RE: 2 Lot Partition; Burchill Partition
Case File Number: PAR 16-0001, Burchill
Response for additional information for completeness of application

Burchill Partition

Land Use Application

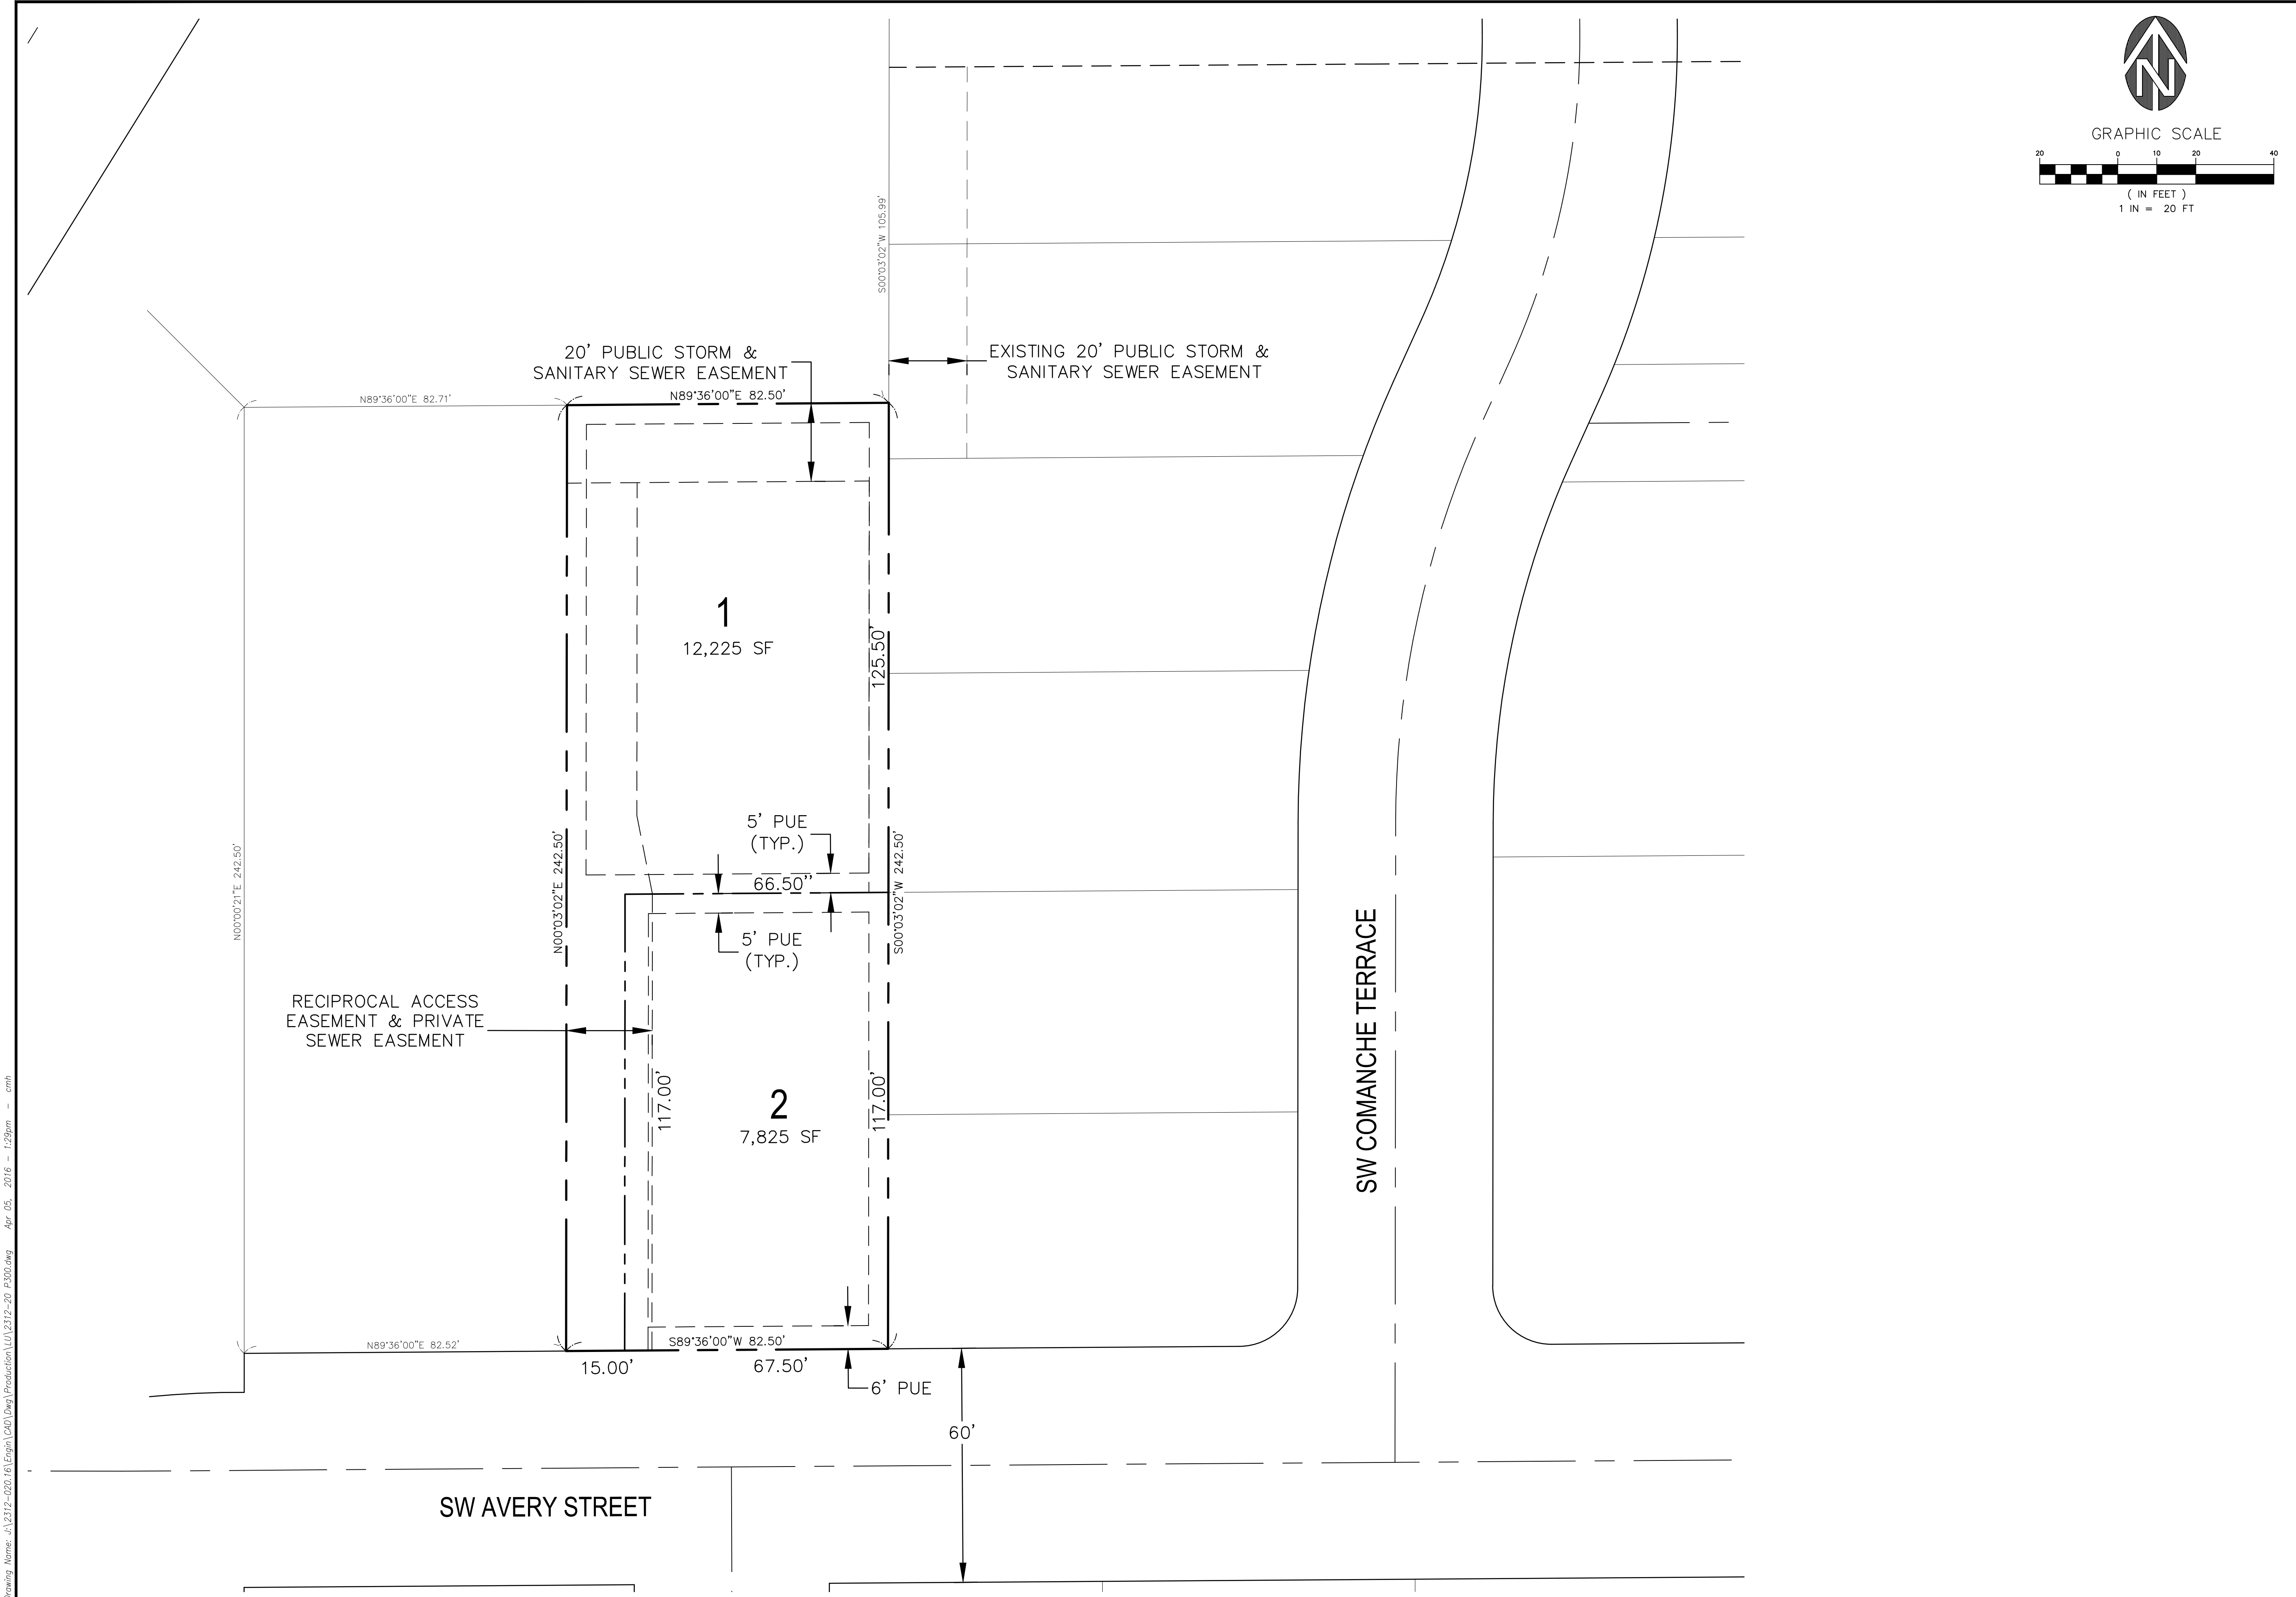
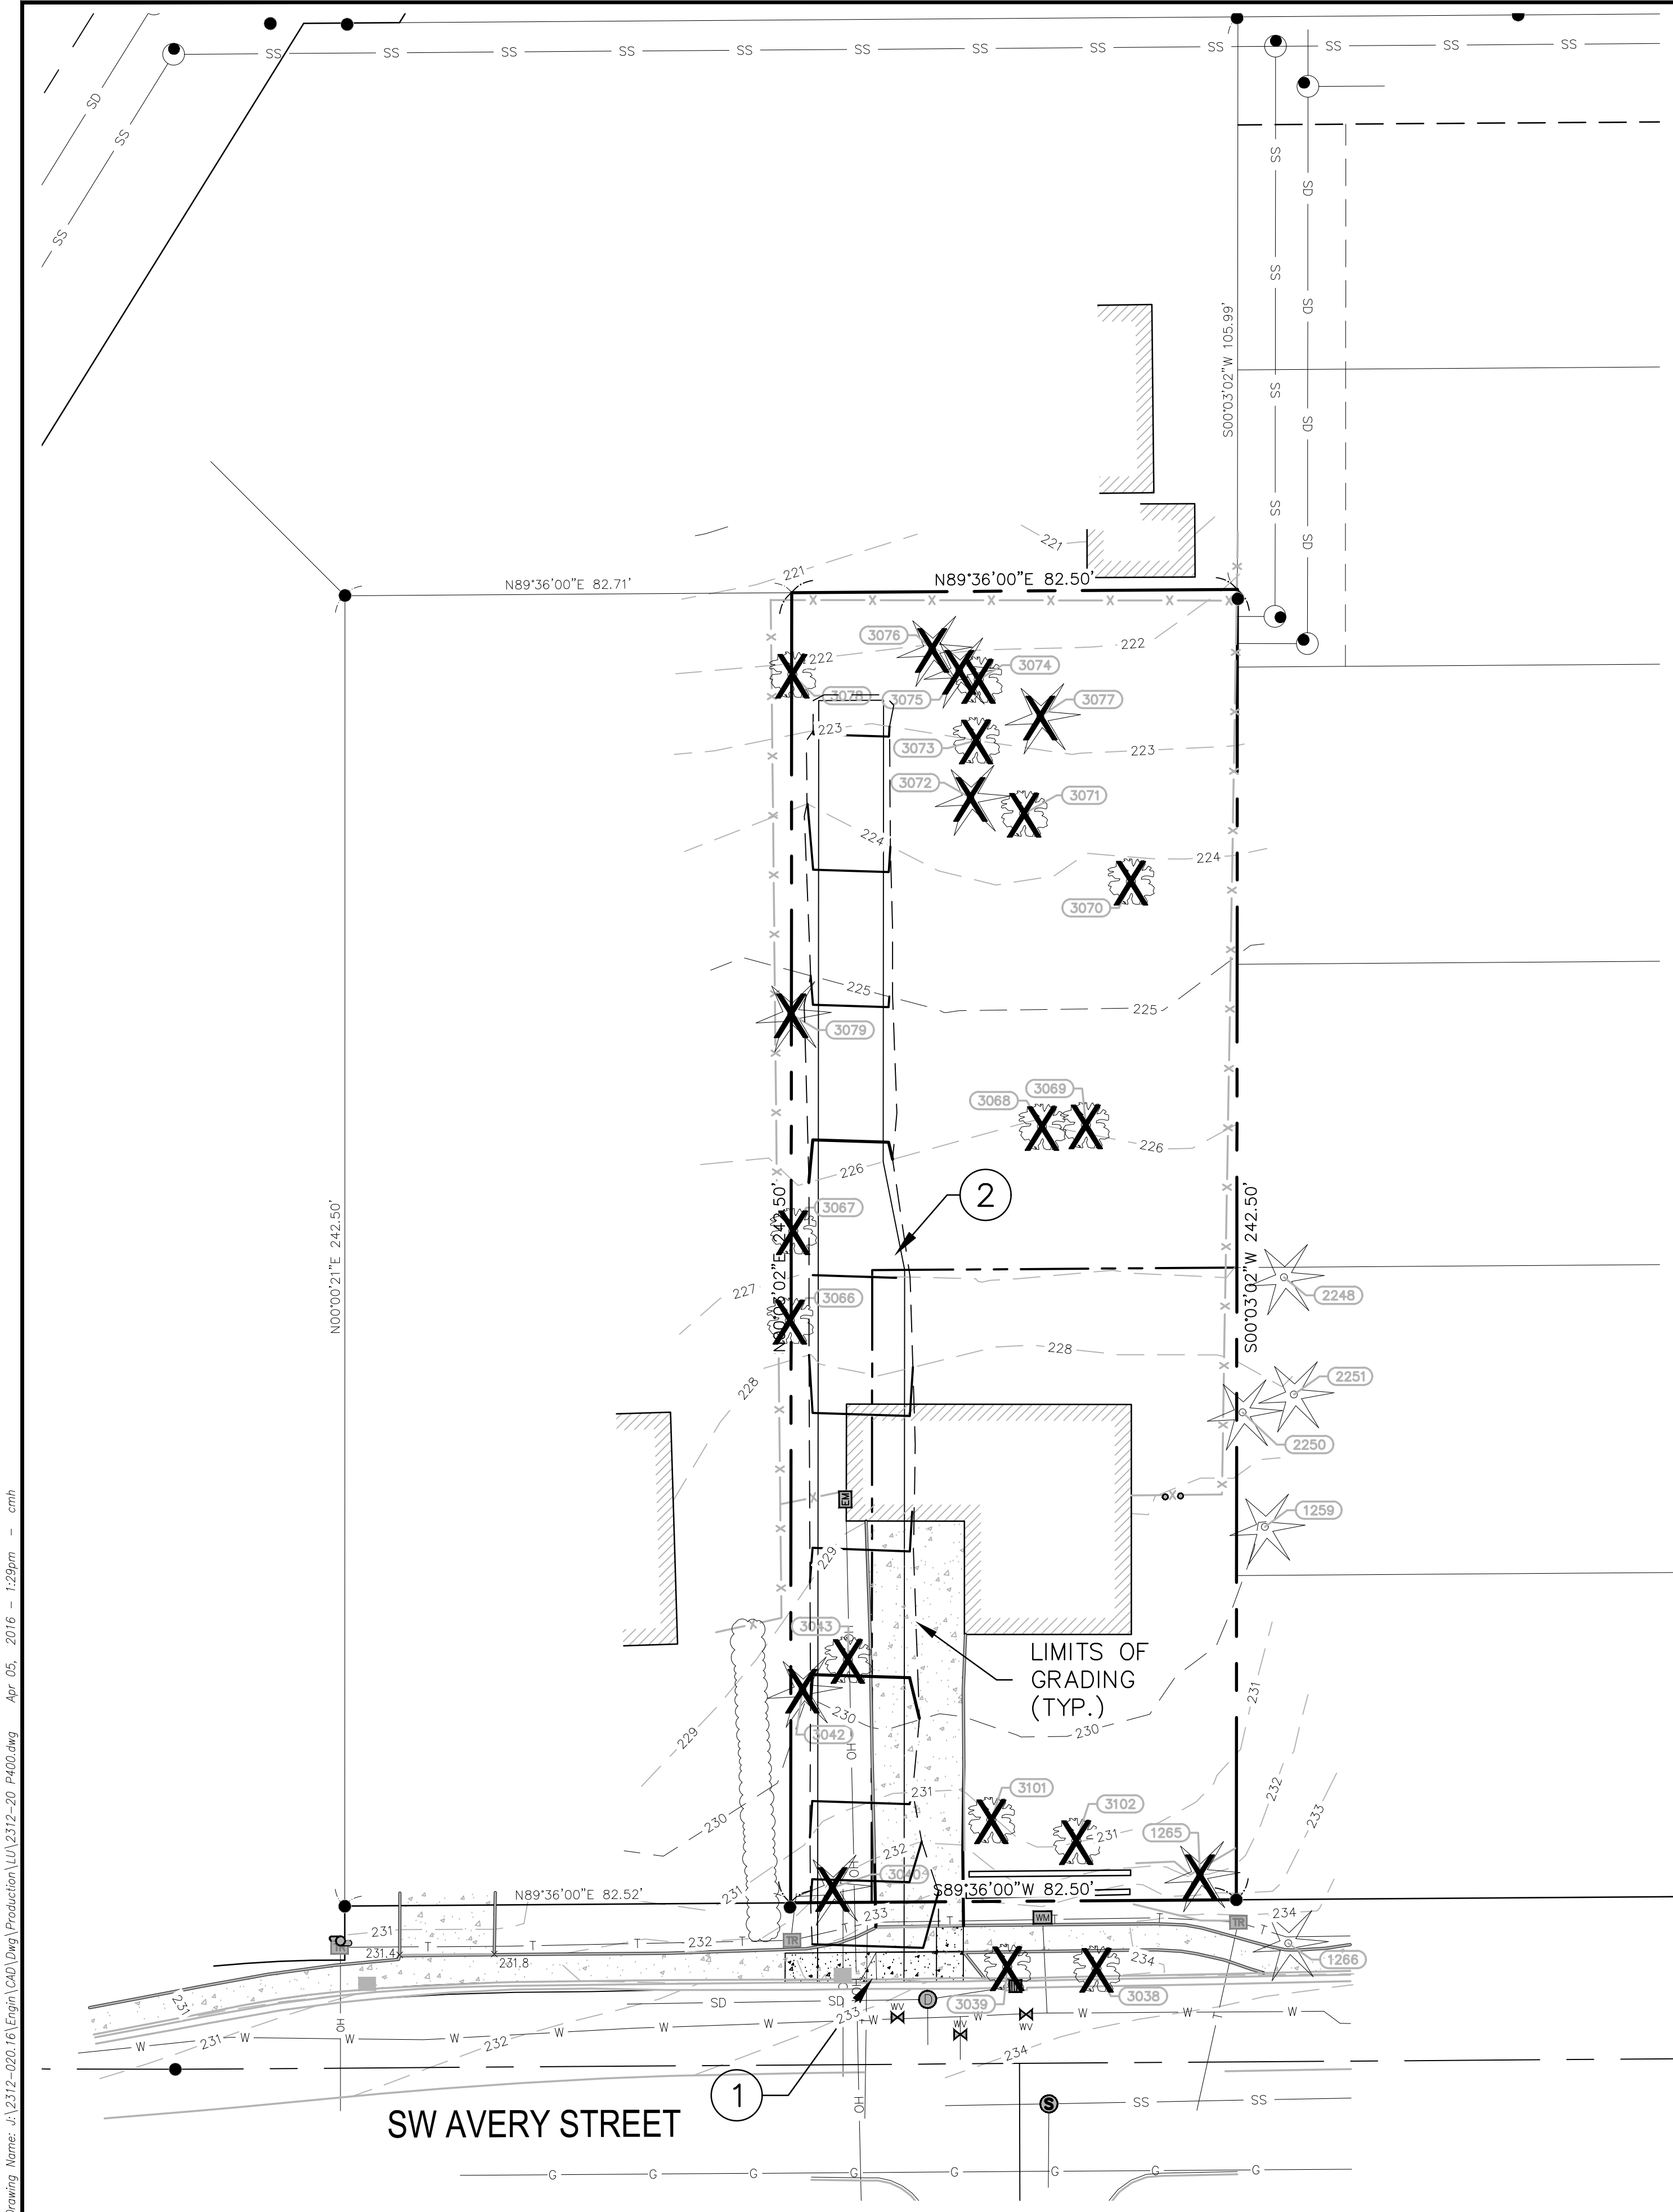
- *The public sanitary sewer and stormwater lines extending from the property east of this development across the north property line in a 20-foot wide easement to the property to the west*
- *Manholes at the northwest corner of the lot with public lines to the west property line*
- *A 15-foot wide maintenance easement with 12-foot wide surface to the manholes (Operations was willing to not require a turn-around despite the length as it would consume too much property and the line would only be cleaned every three years.)*
- *Revise Grading & Tree Plan to identify tree preservation/ removal in accordance with TDC 73.250(2).*

Response: The tree removal plan identifies the trees that are needed to be removed for the partition improvements. Exhibit J contains an arborist’s report which identifies the existing trees on property in accordance with the standards of TDC 34.210. There are no sensitive land areas within the project limits, per CWS provider letter, that impact tree removal.

Response: A tree removal plan is shown with engineering plan set. An arborist report is included as Exhibit J. The trees shown on the plan for removal are necessary for removal due to their location to improvements for partition or their condition.
